**FIRESTONE ESTERO TOWN CENTER CPD**  
**Amendment to Commercial Planned Development**  
**Zoning Staff Report**  
**For Planning & Zoning Board Public Hearing**

<b>PROJECT NAME:</b>	<b>FIRESTONE - ESTERO TOWN CENTER CPD A PORTION OF TRACT A</b>
<b>CASE TYPE:</b>	<b>PLANNED DEVELOPMENT AMENDMENT</b>
<b>CASE NUMBER:</b>	<b>DCI2019-E005</b>
<b>PLANNING &amp; ZONING BOARD DATE:</b>	<b>August 18, 2020</b>

**MASTER CONCEPT PLAN**  
(05/04/20)

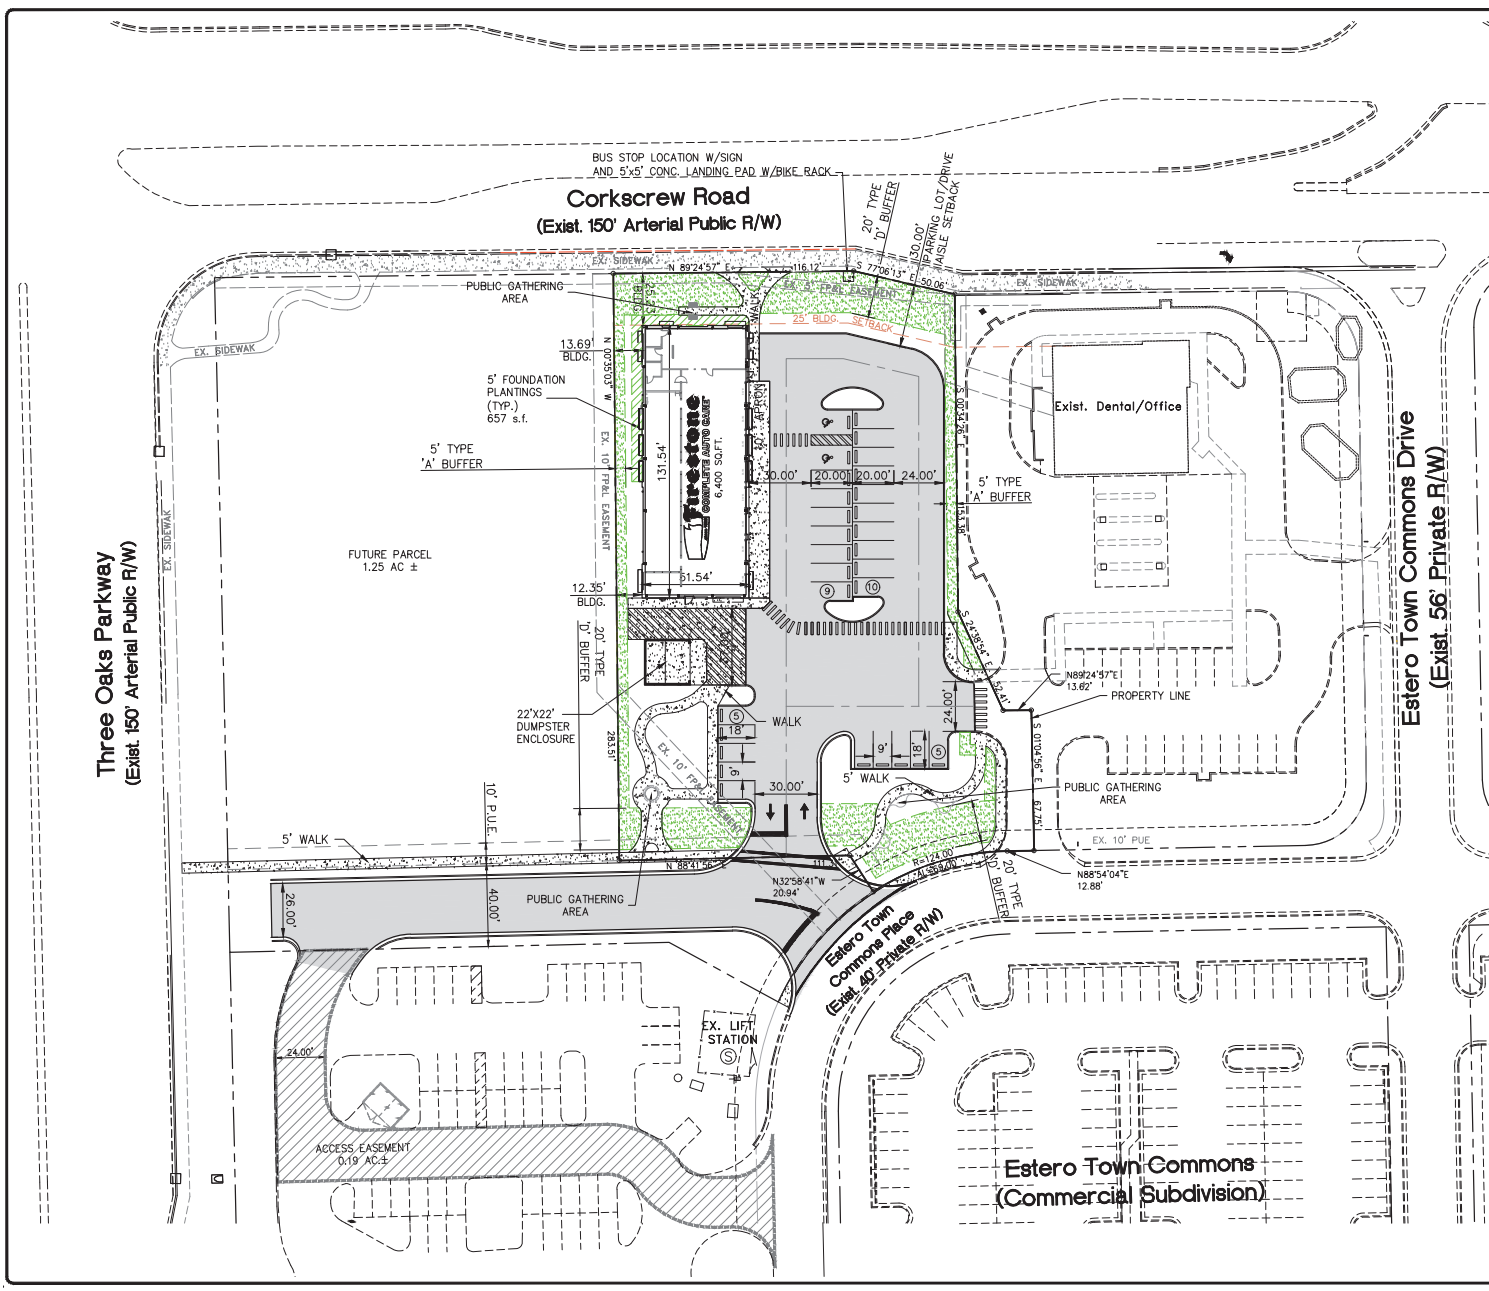
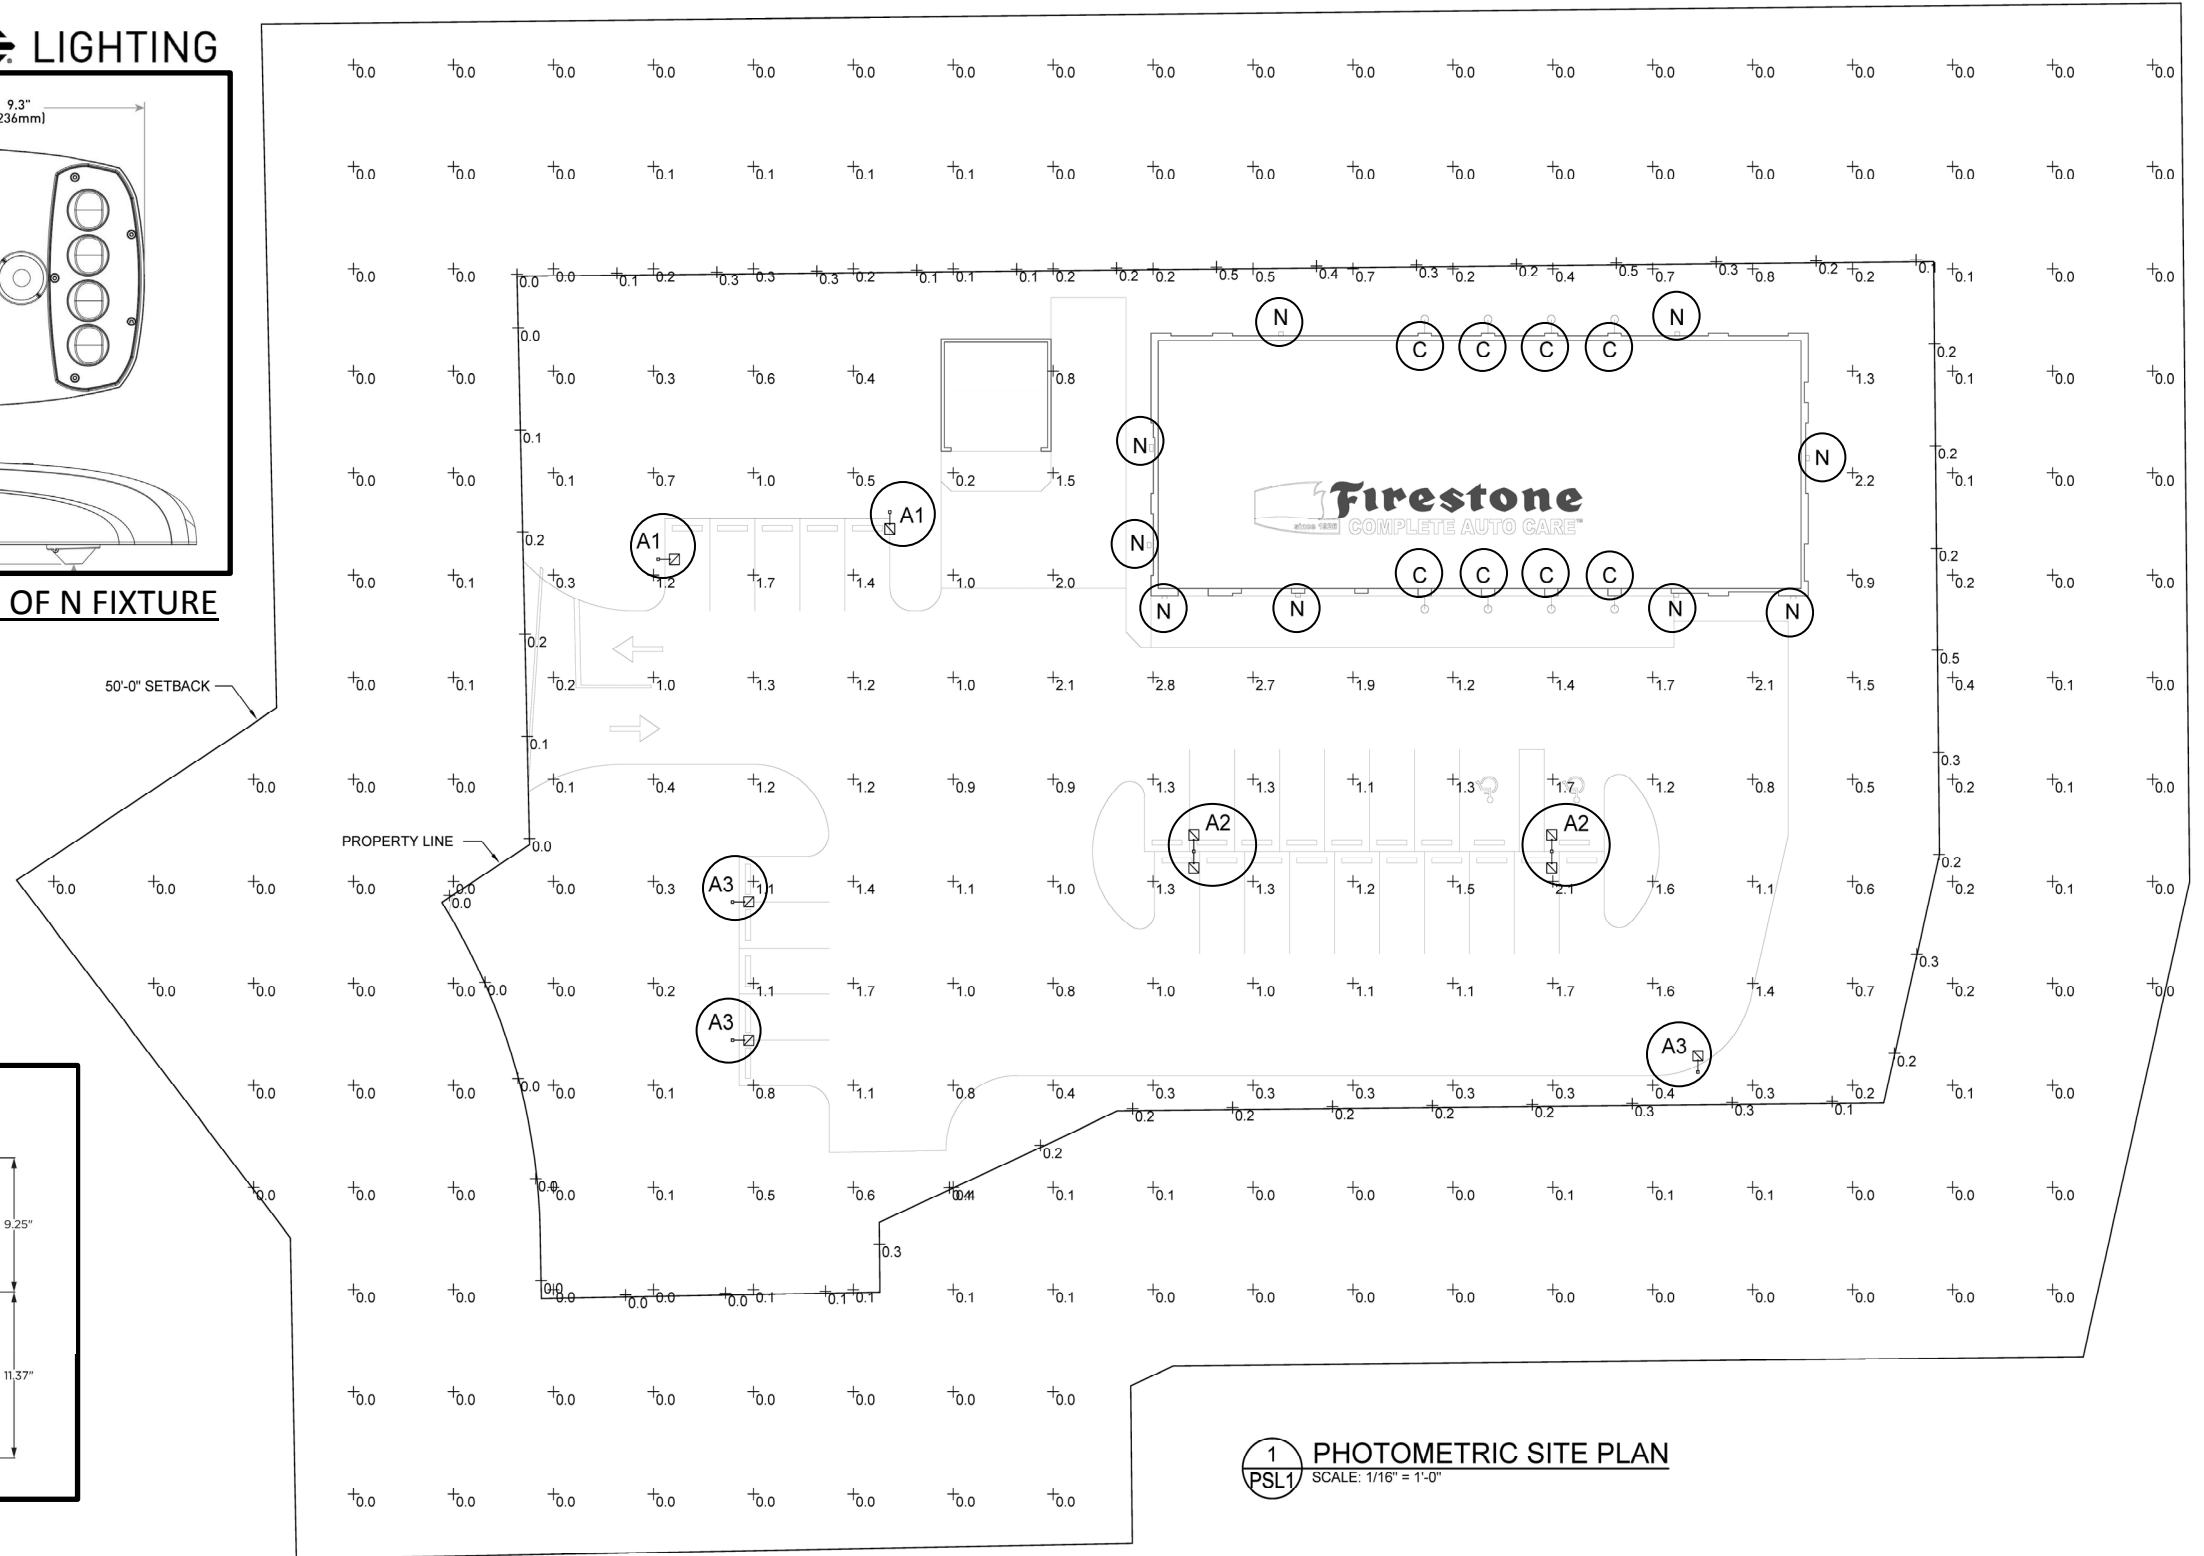
The applicant has provided a Master Concept Plan (MCP) dated May 4, 2020 and stamped “Received May 14, 2020”. The plan depicts a 6,400 square foot Firestone Complete Auto Care facility on 1.4 acres of the parcel with an onsite parking lot that includes 29 spaces, two of which are handicap parking spaces. The LDC requires 23 parking spaces be provided.

The vehicular access is via Estero Town Commons Place, an existing 40 foot private right-of-way, which provides access from Corkscrew Road to the north or from Three Oaks Parkway to the west. Pedestrian access is proposed from Corkscrew Road via a sidewalk which will provide connection to existing pedestrian paths along Three Oaks Parkway and Corkscrew Road, as well as to the existing pedestrian paths within the Estero Town Center development.

Open space is proposed to be .39 acres or 34% of the site, 30% is required by the CPD. Other information on the site plan includes the solid waste enclosure, and three public gathering areas.

The site plan shows the creation of an off-site 40-foot right-of-way from Estero Town Commons Place to the east to serve Tract A. This right-of-way provides outlet via an adjacent parcel, therefore an access easement is required through the adjacent parcel. The applicant has provided a draft easement and a condition is recommended to assure completion of this documentation at the time of plat and development order.

1. Master Concept Plan  
Development of this project must be consistent with the Master Concept Plan (MCP) titled “Master Concept Plan 05/04/20”, stamped “Received May 14, 2020”, except as modified by the conditions below.
